NH PUC Docket DE 16-441:

Petition of PSNH d/b/a Eversource Energy to Construct and Maintain
Electric Lines, Neutral Wire and Fiber Optic Cable Over/Across the
Public Waters of the Oyster River and Little Bay in the Town of Durham,
Pickering Brook and Little Bay in the Town of Newington

SUMMARY
Revisions between Originally Submitted Petition
And Revised Engineering Design

DOUBLE CKT F107 & 380
BETWEEN STR. 28 & 29
OYSTER RIVER, DURHAM, NEW HAMPSHIRE

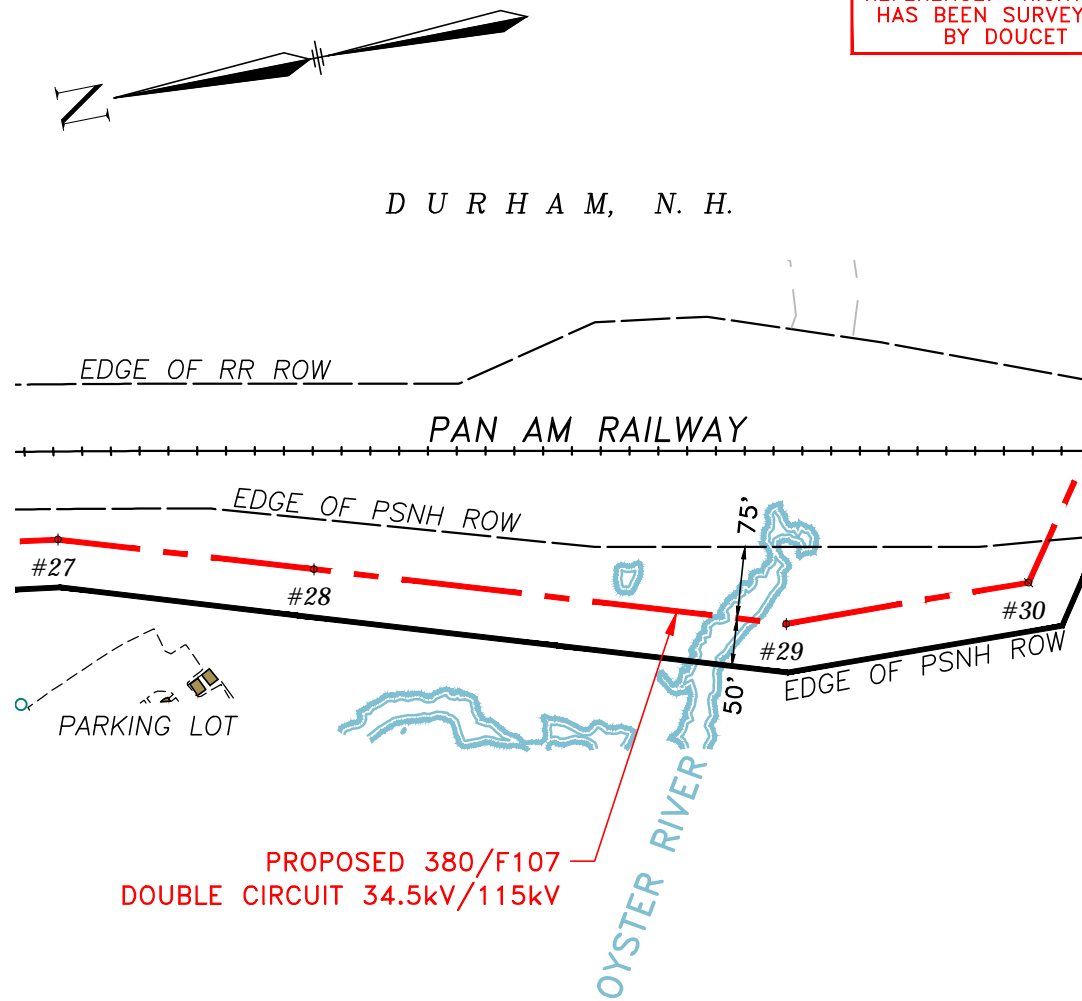
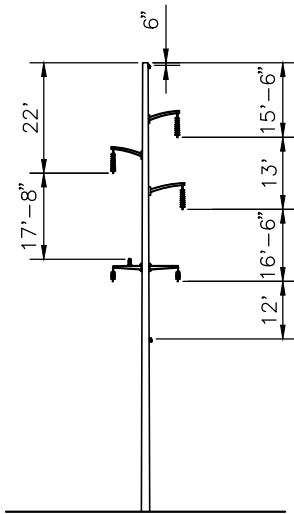
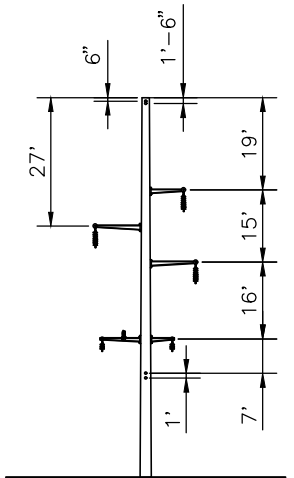
1. Paragraph #1- Revised Drawing number F10740901 (Exhibit 1) has been supplied. There are no changes to the location plan labeled as Drawing number F10740902 (Exhibit 2).

2. Paragraph #1- **Change** “PSNH” to “Eversource Energy”
3. Paragraph #3- **Change** “As shown on Exhibit 1...approximate separation at the structure of 7 - 15 feet vertically ... neutral wire is carried... approximately seven feet down below the 34.5kV phase wires.” to “As shown on Exhibit 1...approximate separation at the structure of 6 - 13 feet vertically...neutral wire is carried... approximately 12 feet down below the 34.5kV phase wires.”

4. Paragraph #5 Bullet 3- **Change** “...a clearance to the water surface of 57.1 feet. ... exceed the minimum clearance requirement of 30.1 feet by 27 feet under temporary emergency conditions during a 10-yr storm event.” to “...a clearance to the water surface of 58.4 feet. ... exceed the minimum clearance

- requirement of 30.1 feet by 28.3 feet under temporary emergency conditions during a 10-yr storm event.”
5. Paragraph #5 Bullet 4- **Change** “... the clearance would be 12 feet vertically ...” **to** “... the clearance would be 12.5 feet vertically ...”

6. Paragraph #5 Bullet 5- **Change** “...clearance would be 8.7 feet vertically and 1 foot horizontally from the shield wires to the closest phase wire...exceed the vertical requirement by 5.8 feet under worst case conditions.” **to** “...clearance would be 13.3 feet vertically and 1 foot horizontally from the shield wires to the closest phase wire...exceed the vertical requirement by 9.9 feet under worst case conditions.”

7. Paragraph #5 Bullet 6- **Change** “...clearance to the water surface of 36.7feet ... exceed the minimum clearance requirement of 28.5 feet by 8 feet under temporary emergency conditions during a 10-yr storm event.” **to** “...clearance to the water surface of 37.2 feet ... exceed the minimum clearance requirement of 28.5 feet by 8.7 feet under temporary emergency conditions during a 10-yr storm event.”

8. Paragraph #5 Bullet 7- **Change** “...clearance to the water surface of 30.3 feet. ...exceed the minimum clearance requirement of 25.5 feet by 4.8 feet under temporary emergency conditions during a 10-yr storm event.” **to** “...clearance to the water surface of 31.1 feet. ...exceed the minimum clearance requirement of 25.5 feet by 5.6 feet under temporary emergency conditions during a 10-yr storm event.”

9. Paragraph #5 Bullet 8- **Change** “...clearance of the closest 34.5kV line would be 1.5 feet vertically and 0 feet horizontally ... exceed the vertical requirement by 0.2 feet under worst case conditions.” **to** “...clearance of the closest 34.5kV line would be 2.5 feet vertically and 0 feet horizontally ... exceed the vertical requirement by 1.2 feet under worst case conditions.”

4	UPDATED SAGS	8/16	SCF	APJ	-
3	UPDATED F107 STRUCTURE NUMBERS	11/15	SCF	APJ	-
NO.	REVISION	DATE	DRWN	CHKD	APPR

SINGLE CKT F107
BETWEEN STR. 119 & 120
PICKERING BROOK, NEWINGTON, NEW HAMPSHIRE

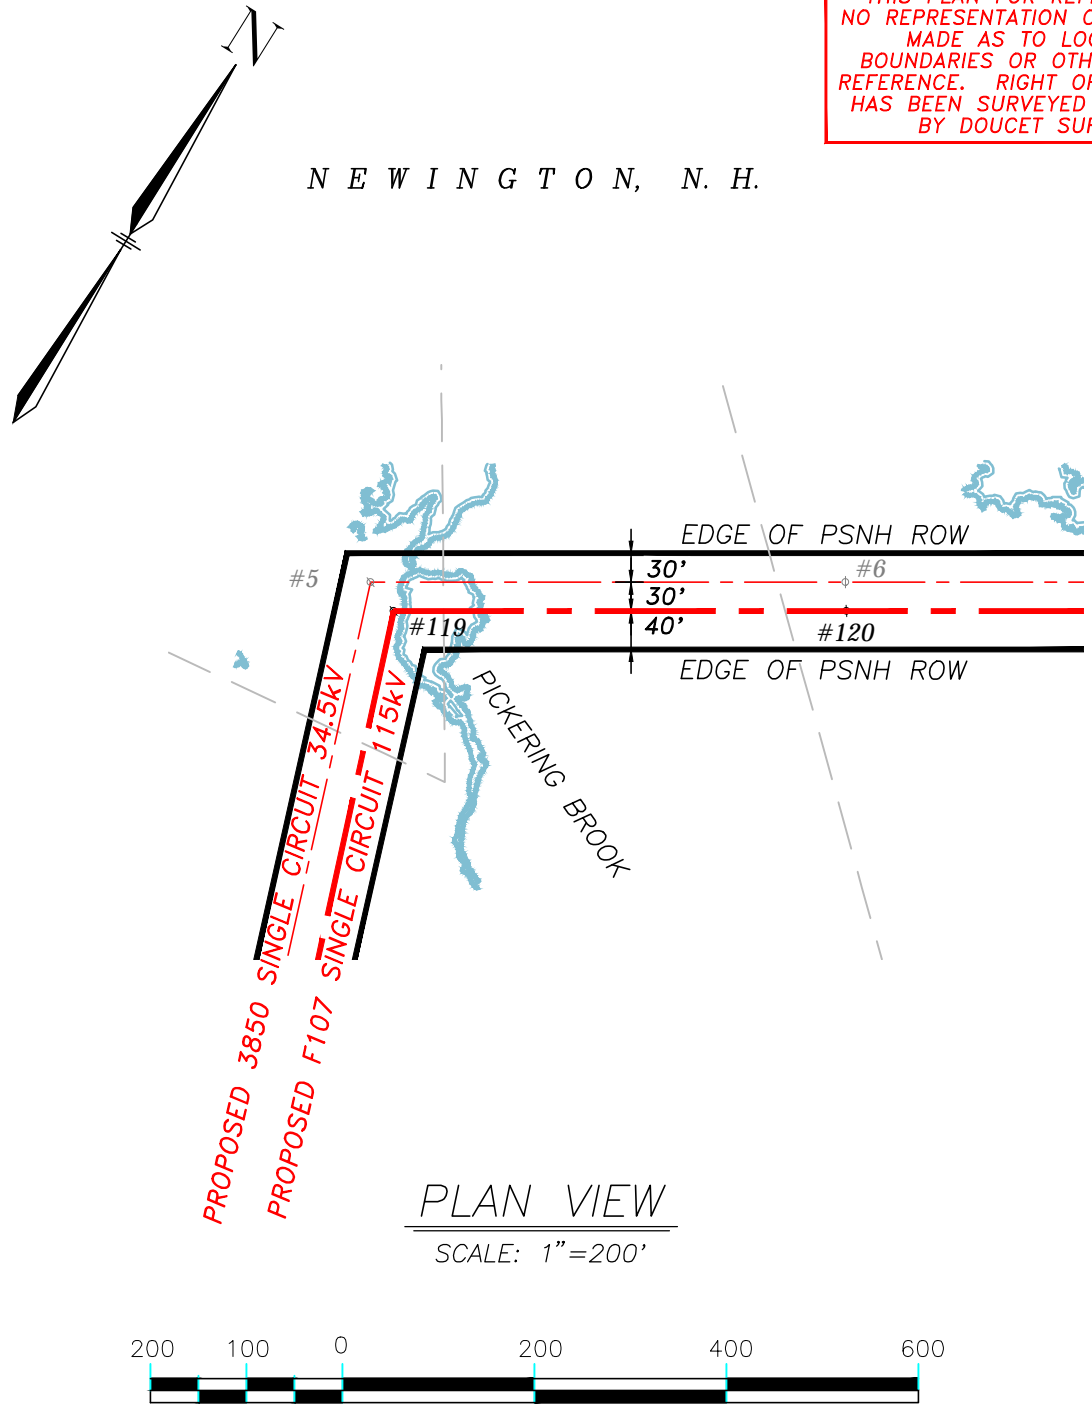
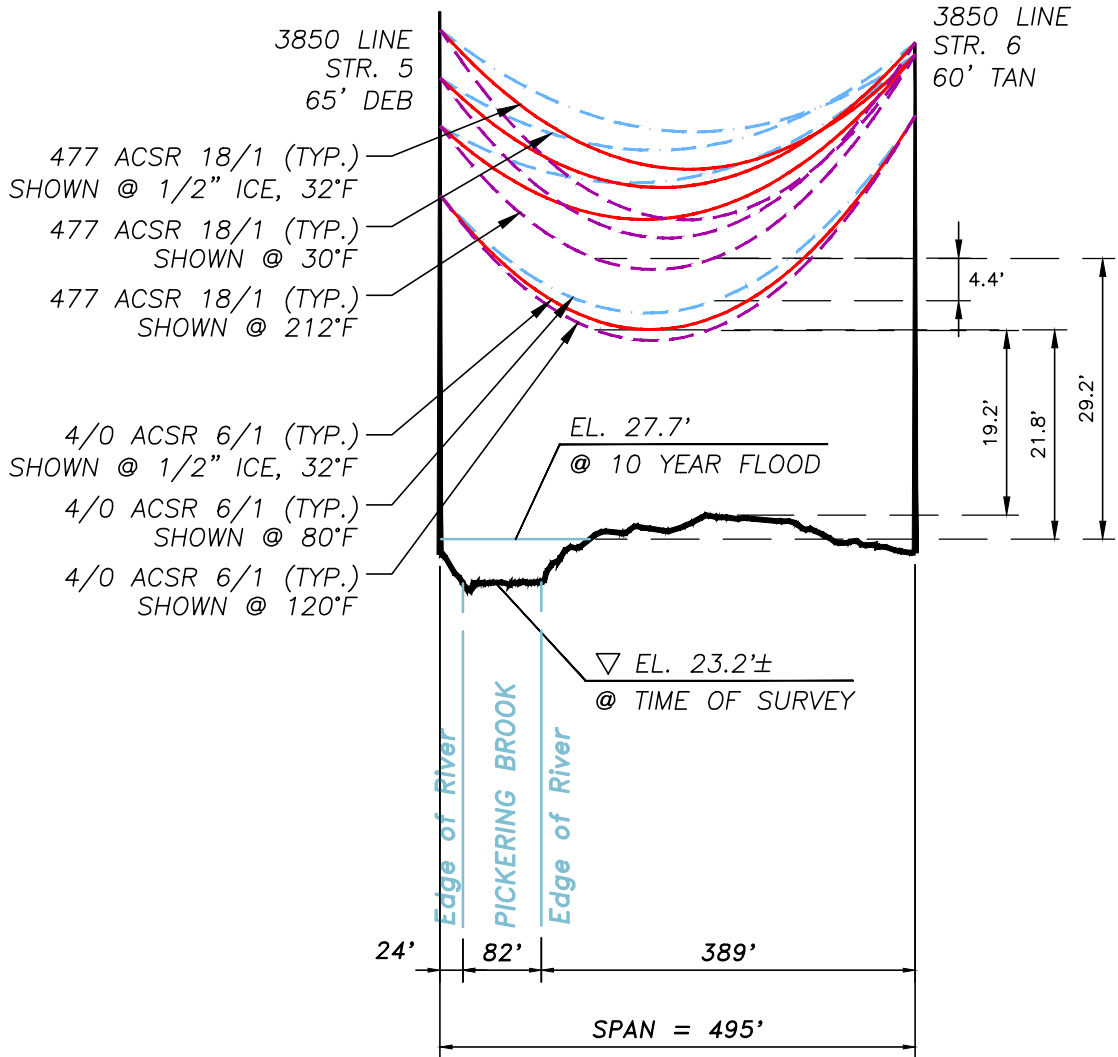
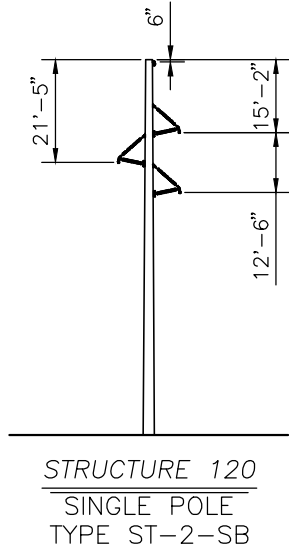
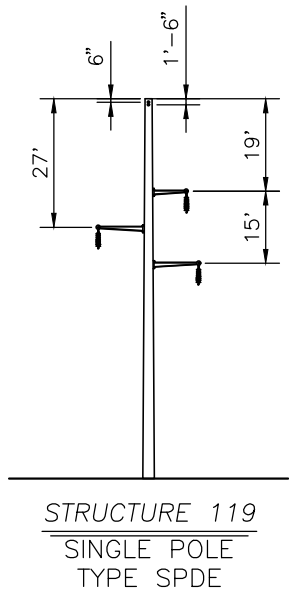
1. Paragraph #1- Revised Drawing numbers F10740903 (Exhibit 3) and 385040901 (Exhibit 5) have been supplied. There are no changes to the location plans labeled as Drawing numbers F10740904 (Exhibit 4) and 385040902 (Exhibit 6).

2. Paragraph #1- **Change** “PSNH” **to** “Eversource Energy”
3. Paragraph #3- **Change** “As shown on Exhibit 3...separation at the structure of 8 -15 feet vertically” **to** “As shown on Exhibit 3...separation at the structure of 6 -12.5 feet vertically”

4. Paragraph #3- **Change** “A clearance of 26.2 feet...NESC required clearance of 20.1 feet by 6.1 feet.” **to** “A clearance of 27.2 feet...NESC required clearance of 20.1 feet by 7.1feet.”

9. Paragraph #6, Bullet 3- **Change** "...a clearance to the water surface of 34.1 feet.... exceed the minimum clearance requirement of 22.1 feet by 12 feet under temporary emergency conditions during a 10-yr storm event." **to** "...a clearance to the water surface of 34.6 feet.... exceed the minimum clearance requirement of 22.1 feet by 12.5 feet under temporary emergency conditions during a 10-yr storm event."

10. Paragraph #6, Bullet 4- **Change** "Under these conditions the clearance would be 13.5 feet vertically..." **to** "Under these conditions the clearance would be 12.5 feet vertically..."

5	UPDATED SAGS	8/16	SCF	APJ	-
4	UPDATED F107 STRUCTURE NUMBERS	12/15	SCF	APJ	-
NO.	REVISION	DATE	DRWN	CHKD	APPR

SINGLE CKT 3850
BETWEEN STR. 5 & 6
PICKERING BROOK, NEWINGTON, NEW HAMPSHIRE

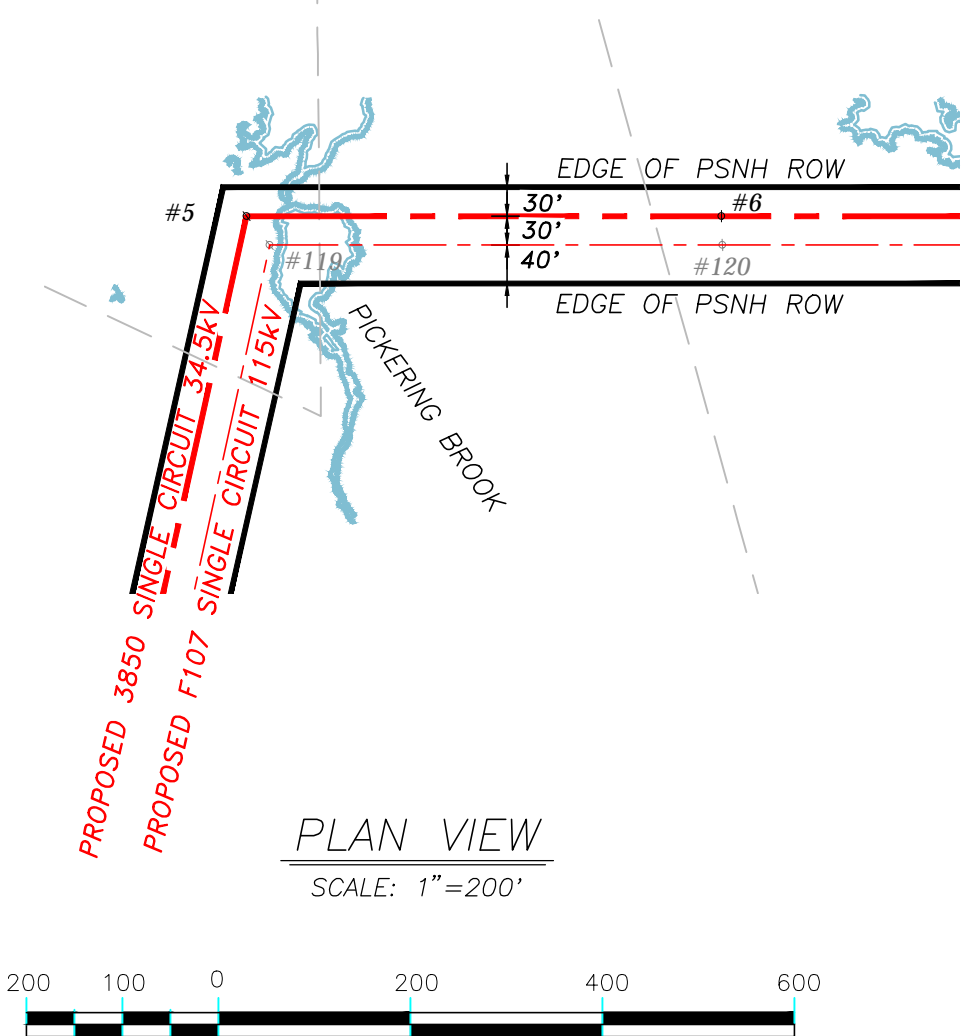
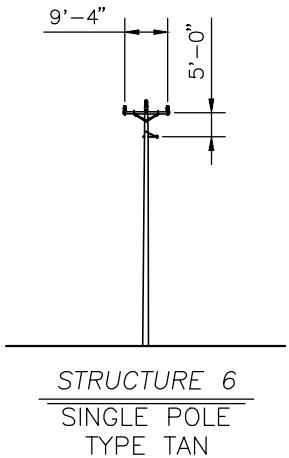
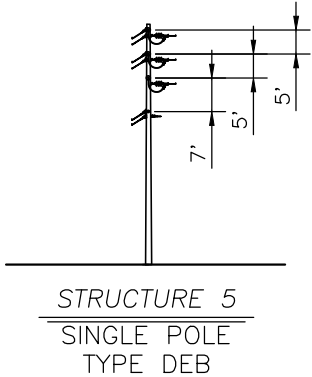
5. Paragraph #4- **Change** “...1-pole, direct embed, 60 foot pole (eight feet embedded), wood deadend structure (western side)...” **to** “...1-pole, direct embed, 65 foot pole (8.5 feet embedded), wood deadend structure (western side)...”

6. Paragraph #4- **Change** "...separation at the structure of five feet vertically and 0-9 feet horizontally in a horizontal configuration." **to** "...separation at the structure of five feet vertically and 0 feet horizontally in a vertical configuration."

7. Paragraph #4- **Change** "for Structure 5...approximately five feet..." **to** "for Structure 5...approximately seven feet..."
8. Paragraph #4- **Change** "A clearance of 21 feet between...NESC required clearance of 15.5 feet by 5.5 feet." **to** "A clearance of 19.2 feet between...NESC required clearance of 15.5 feet by 3.7 feet."

11. Paragraph #6, Bullet 5- **Change** "...a clearance to the water surface of 31.9 feet. ...exceed the minimum clearance requirement of 20.5 feet by 11.4 feet under temporary emergency conditions..." **to** "...a clearance to the water surface of 29.2 feet. ...exceed the minimum clearance requirement of 20.5 feet by 8.7feet under temporary emergency conditions..."

12. Paragraph #6, Bullet 6- **Change** "...a clearance to the water surface of 23.5 feet. ... exceed the minimum clearance requirement of 17.5 feet by 6 feet under temporary emergency conditions during a 10-yr storm event." **to** "...a clearance to the water surface of 21.8 feet. exceed the minimum clearance requirement of 17.5 feet by 4.3 feet under temporary emergency conditions during a 10-yr storm event."

13. Paragraph #6, Bullet 7- **Change** "...clearance of the closest 34.5kV line would be 2.4 feet vertically and 0 feet horizontally from the neutral wire ... will exceed the vertical requirement by 1.1 feet under worst case conditions." **to** "...clearance of the closest 34.5kV line would be 4.4 feet vertically and 0 feet horizontally from the neutral wire ... will exceed the vertical requirement by 3.1 feet under worst case conditions."

5	ISSUED FOR SEC AMENDMENT	1/17	SCF	APJ	-
4	REVISED 30 PERCENT DESIGN	9/16	SCF	APJ	-
NO.	REVISION	DATE	DRWN	CHKD	APPR
